# **THE STAR MODIFICATION 14 (MP 08\_0098)**

## **HERITAGE RESPONSE TO COMMENTS**

05A SPOTLIGHT TO COLUMNS - ELEVATION  
1404 SCALE N/A

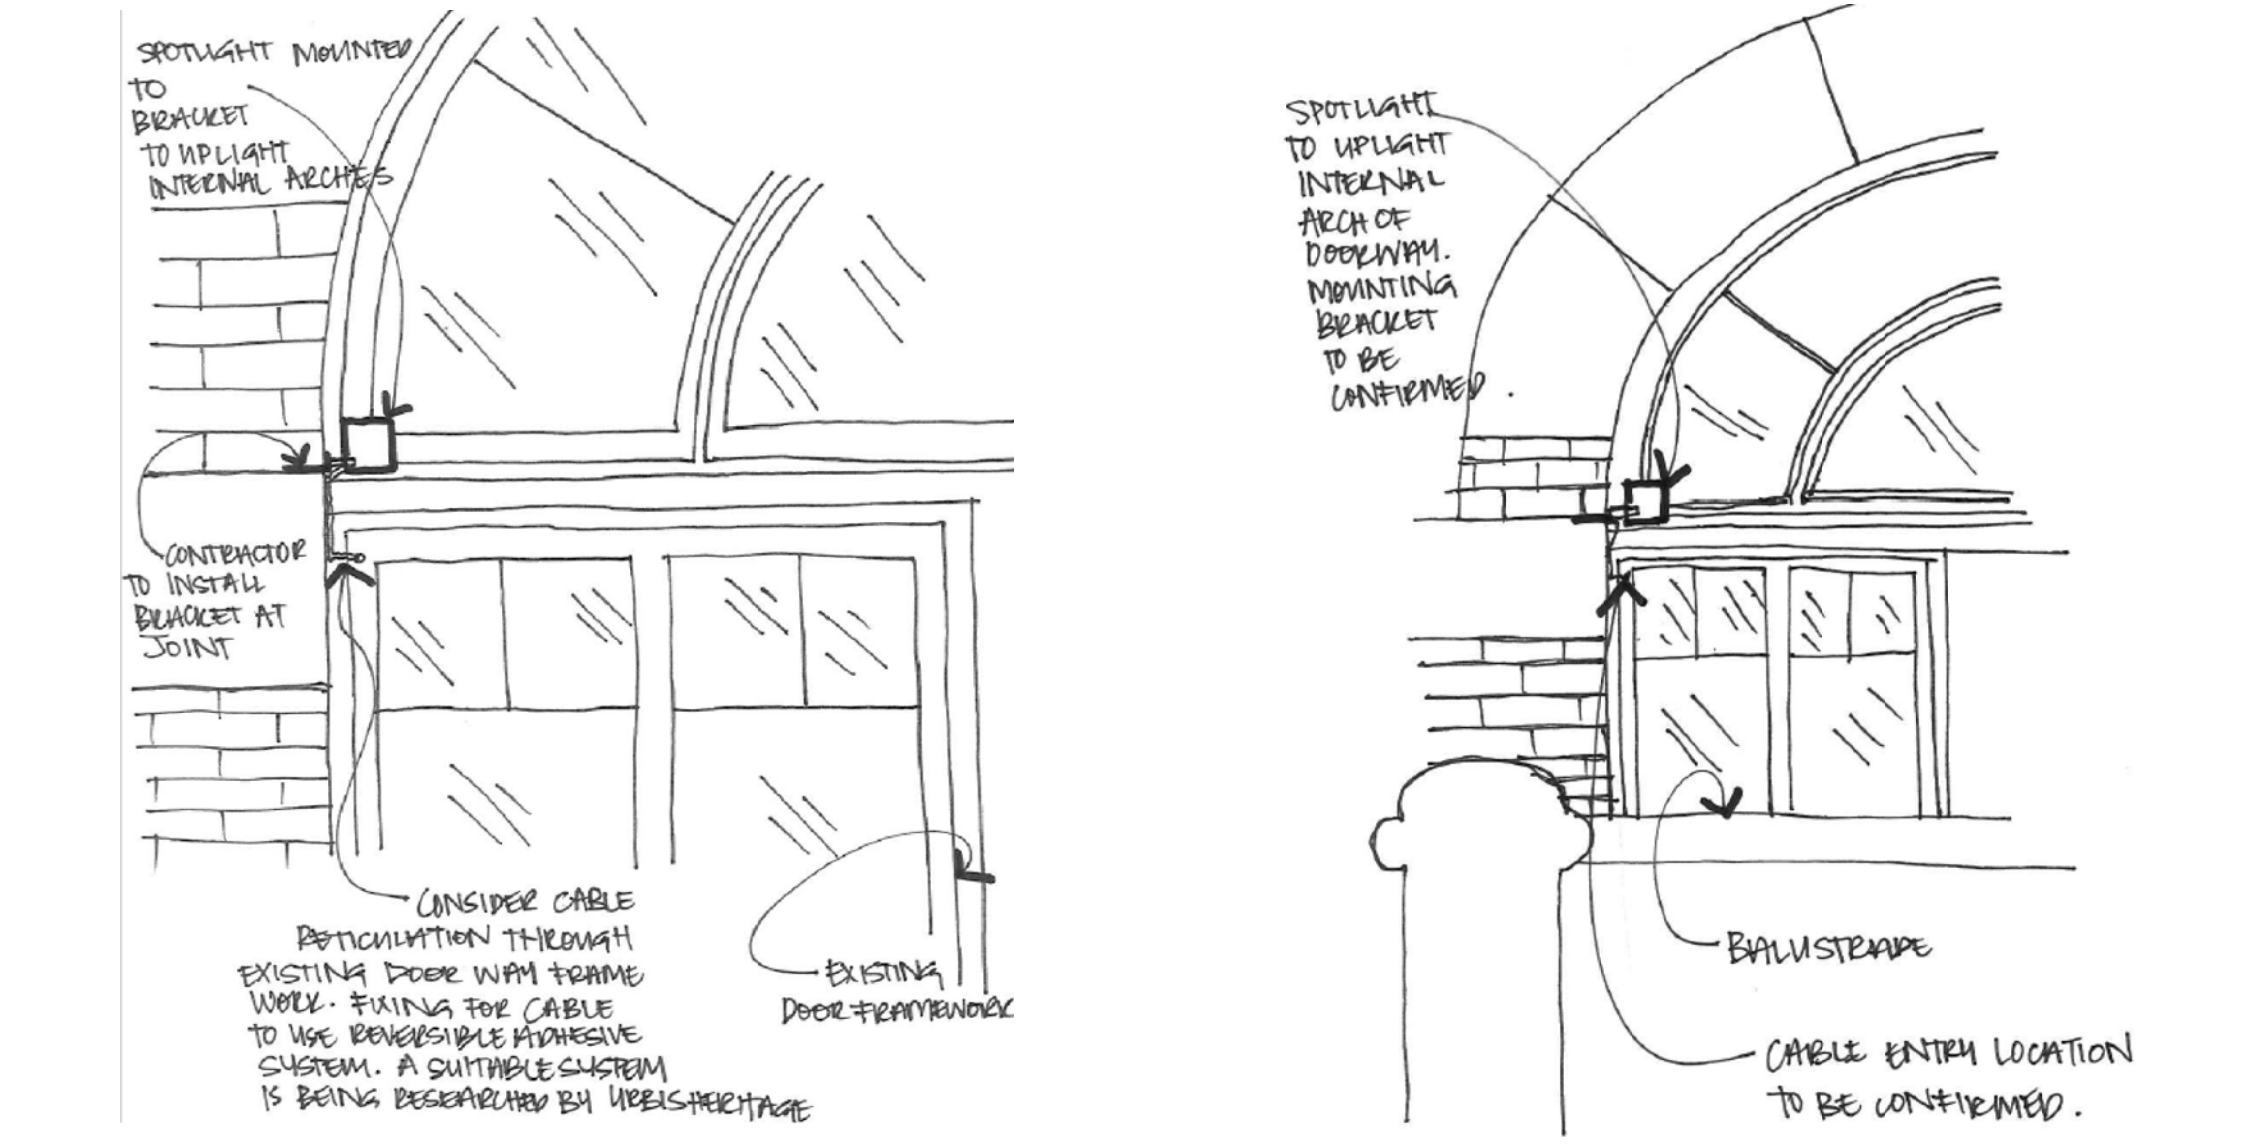
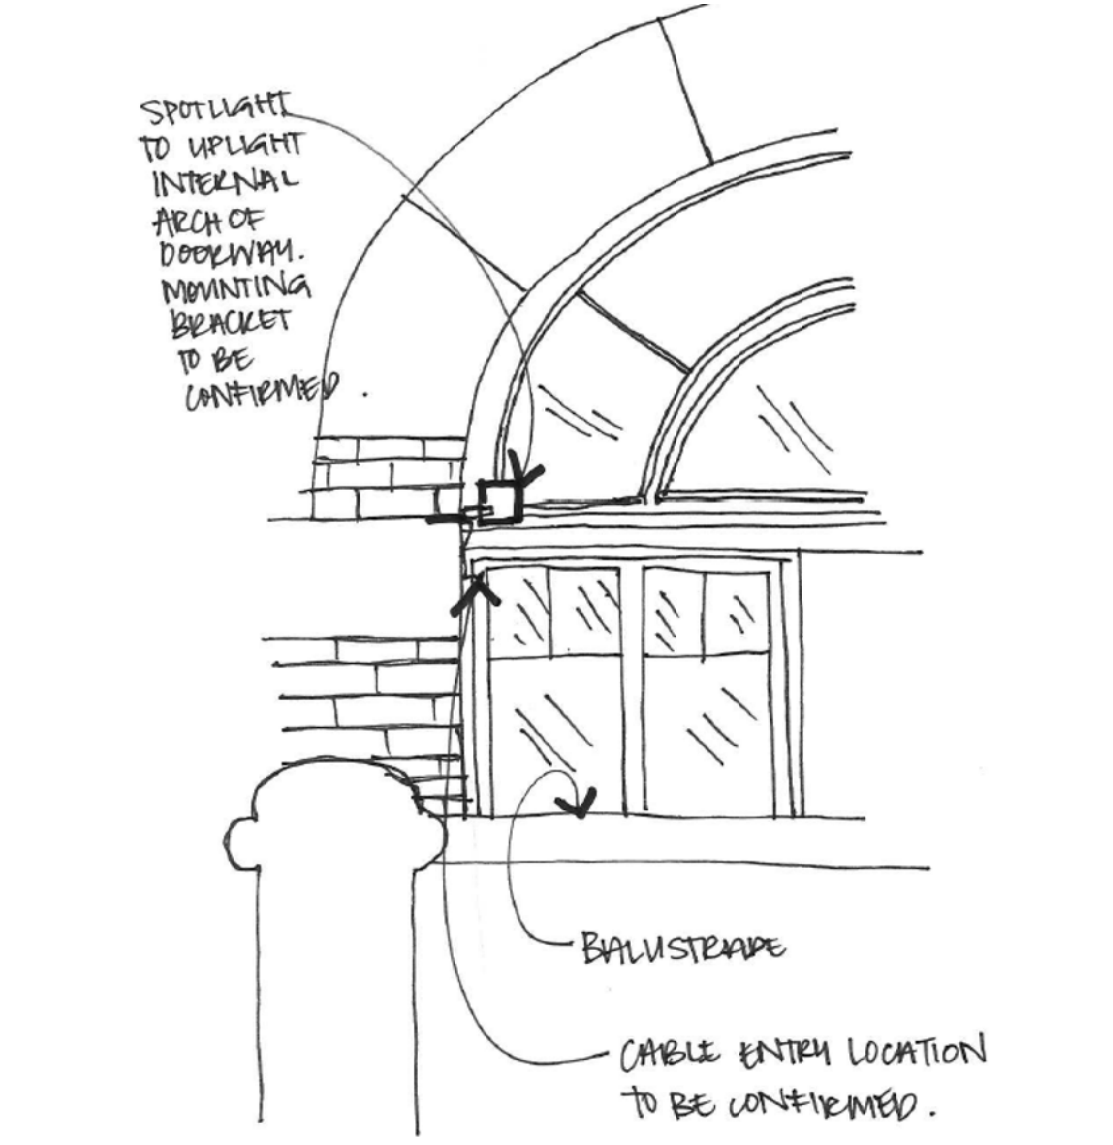
**(Refer Section 2.1 below for discussion).**
- *Any proposed changes to the external lighting to The SELS building should be in keeping with the recommendations made in the Heritage Impact Statement report, by URBIS Pty Ltd. In addition, a mock-up of the proposed lighting effects to the The SELS building should be organised, on site, to be inspected and approved by a suitably qualified heritage consultant.*

**(Refer Section 3.5 below for discussion).**
- *In relation to proposed lighting to the Pyrmont Street façade of the SELS Building, the report by Point of View includes a drawing “to convey design intent only” but the details are not shown on the submitted plans.*

The accompanying drawings have been provided as a mock up of the proposed lighting to The SELS. The lighting has been developed in accordance with the Dialux Render provided in Mod 14, the recommendations set down in the HIS by Urbis and with ongoing consultation with Urbis.

A methodology has been prepared by Urbis in collaboration with Point of View to ensure the appropriate treatment of the heritage item. In summary, the lighting strategy methodology ensures that the proposed strategy avoids penetrations into brick and stone fabric, and minimises the sizes of any penetrations through other fabric. The methodology statement also aims to minimise the visual impact of the light fittings and cabling.

| Drawing           |                      | WATER FEATURE DETAILS        |     |       |

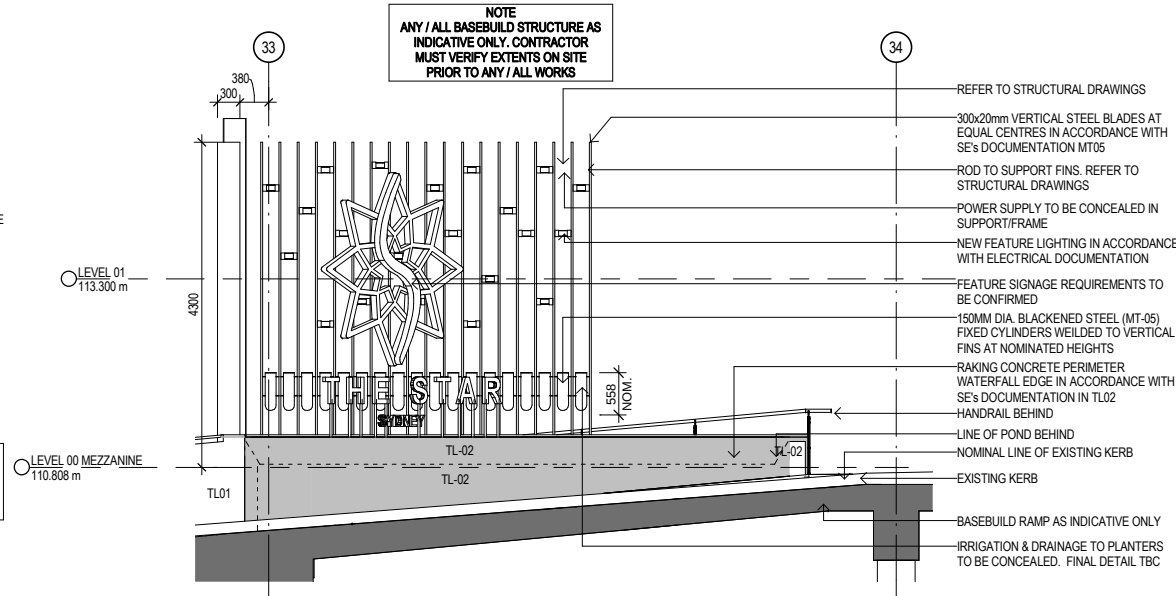
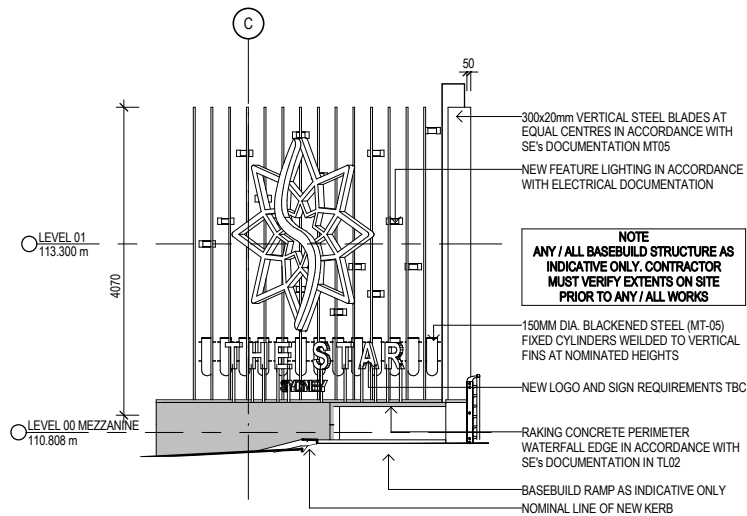
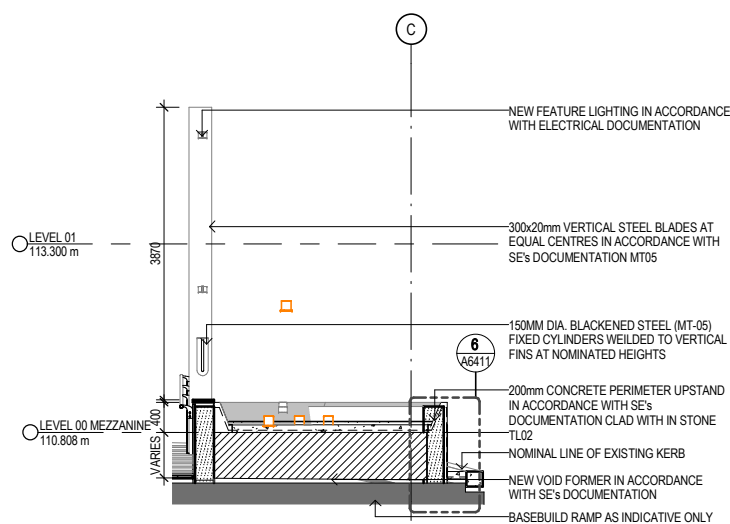
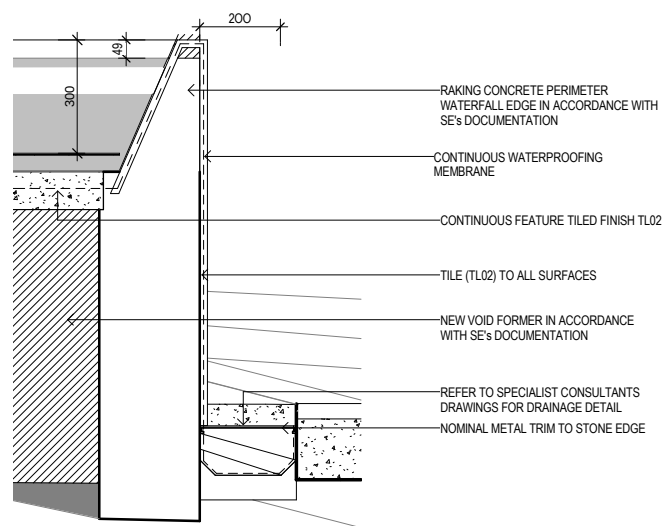
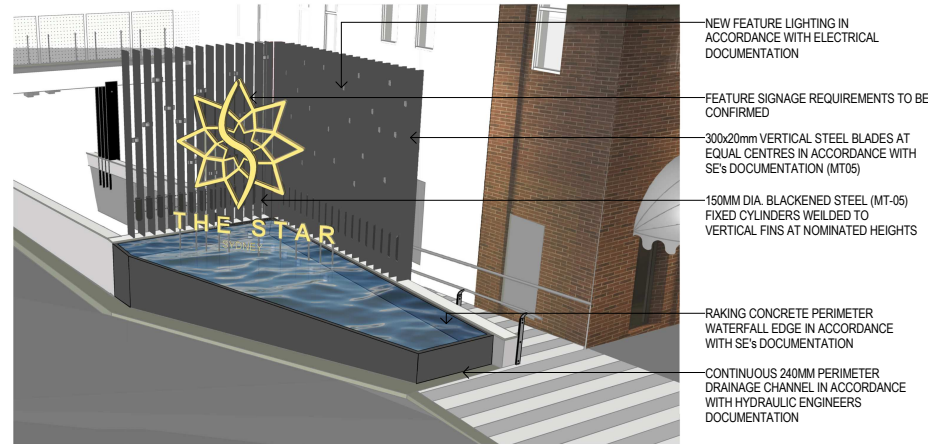
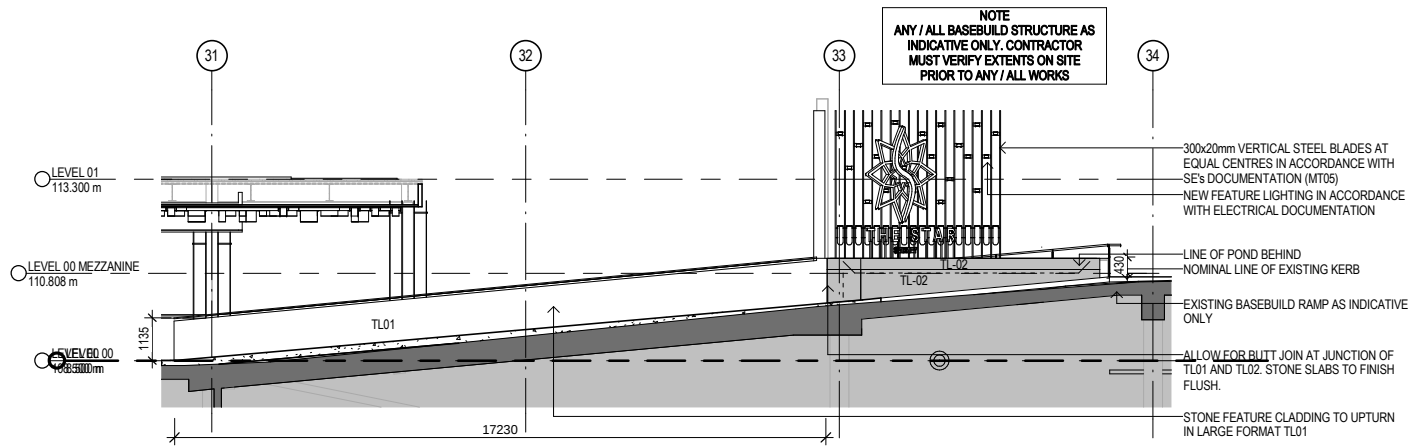
- *The design of the proposed water feature, including its form, proportions, material and colour should sit well and engage harmoniously with the architectural style of The SELS building. More information and design detail should be submitted by the applicant to enable proper assessment.*

**(Refer Section 3.7 below for discussion).**
- *In relation to the proposed water feature and sculpture on the porte cochere side of the SELS building, no details have been submitted on the drawings for this feature. In pre DA advice given by the City to The Star, the City recommended that to reduce its visual impact on the SELS building the water feature structure should be no forward of the line of the face brick return of the SELS building and be reduced in height such that the top of it is no higher than the base of the sill of the first floor double hung sash window within this brick return section of the building.*

The water feature has been designed such that it does not extend higher than the sill height of the first floor window openings on the eastern façade of The SELS. It has been sympathetically sited such that it sits minimally forward of the face brick return of the northern façade. This is in line with the Pre DA feedback received from the City of Sydney Council heritage advisor in 2016 and would mitigate the visual impact of the fountain on the primary (north) façade of The SELS.

The water feature has been designed such that it is not higher than the sill height of the first floor window openings on the eastern façade of The SELS. It has been sympathetically sited such that it sits minimally forward of the face brick return of the northern façade. This is in line with the Pre DA feedback received from the City of Sydney Council Heritage advisor in 2016 and would mitigate the visual impact of the fountain on the primary (north) facade.
